Access Compliance Report Public Rights-of-Way (Pedestrian Signals)

Main Street: REATA_RD Cross Street: ORTEGA_HWY Location: NE

ADA ID: SGRK211118131005 Signal Type: One Push Button-Non APS Overall Compliance: No Severity Scores: BTN 1: 35 BTN 2: N/A No BTN: N/A

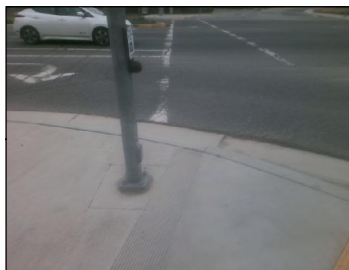
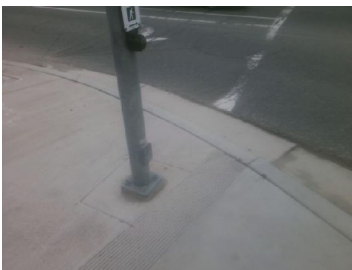
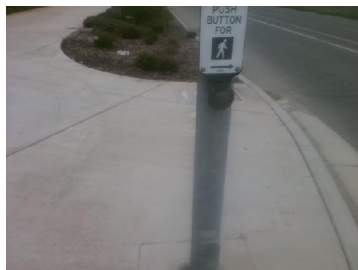
OC Std/PROW: R404.2, R404.3, MUTCD 4e.08

Possible Solutions: Replace Signal Push Button With APS Button. Remove and Replace Clear Space.
